Amendment Notice 2

Licence Number L8721/2013/1

Licensee Karara Mining Limited

Premises Karara Minesite Beneficiation Plant
M59/644, M59/645, G59/38 and L59/99
PERENJORI
WA 6620

Map 6: TSF 2A layout

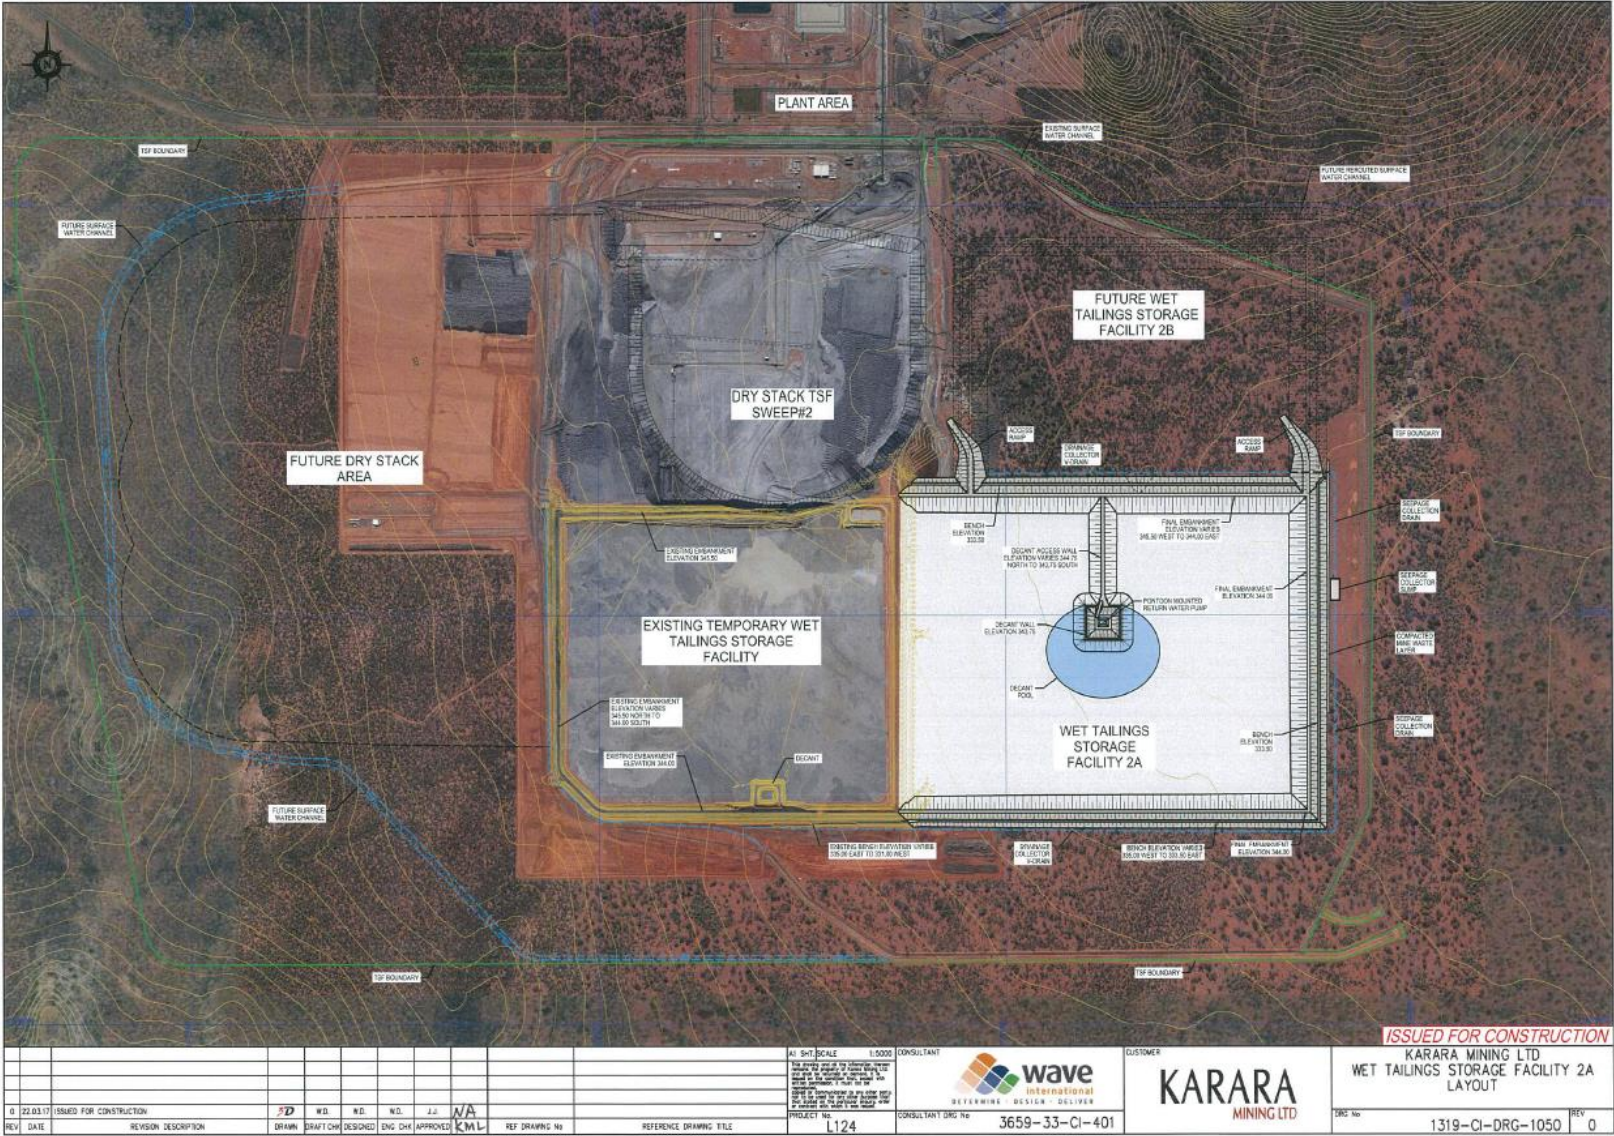
7. The Licence is amended by the addition of Map 6: TSF 2A layout, as shown below.
8. The Licence is amended by the addition of Map 7: Seepage Collection Sump, as shown below.
9. The Licence is amended by the addition of Map 8: TSF drainage and seepage plan and indicative monitoring locations, as shown below.

<u>Location</u>	<u>Requirements</u>	<u>Location and construction details reference map</u>
<u>TSF 2A</u>	<p><u>Sized to contain a 1:100 year ARI, 72 hour rainfall event for net operational storage capacity of 12 million m³.</u></p> <p><u>Top of the embankment elevations will vary from RL 344.0 to RL 345.25 m AHD.</u></p> <p><u>Core of embankments constructed with material with hydraulic conductivity of 1.0×10^{-8} m/s or less.</u></p> <p><u>A key trench constructed along the southern embankment and one third section of the eastern embankment footprints to allow seepage to be directed to the Seepage Collection Sump.</u></p> <p><u>The northern section and the other two thirds of the eastern section embankment footprints, constructed to function as a drainage layer for seepage collection by a toe drain reporting to the Seepage Collection Sump.</u></p> <p><u>Constructed so that seepage will drain to a Seepage Collection Sump.</u></p> <p><u>Four piezometers installed in each embankment wall.</u></p> <p><u>Tailings delivery pipelines constructed of 250 mm diameter HDPE and Victaulic jointed steel lines.</u></p> <p><u>Tailings return pipelines constructed of 250 mm diameter HDPE.</u></p> <p><u>Tailings delivery and return water pipelines and pumps bundled by earthen trenches.</u></p> <p><u>A floating pontoon mounted pump constructed near the centre of the TSF and so that decant water is able to be pumped to the process plant via return pipeline.</u></p> <p><u>Spigots, for subaerial deposition of tailings, located on perimeter of embankments at up to 70 m centres.</u></p>	<p><u>Schedule 1: Map 6: TSF 2A layout, and Map 7: Seepage Collection Sump</u></p>
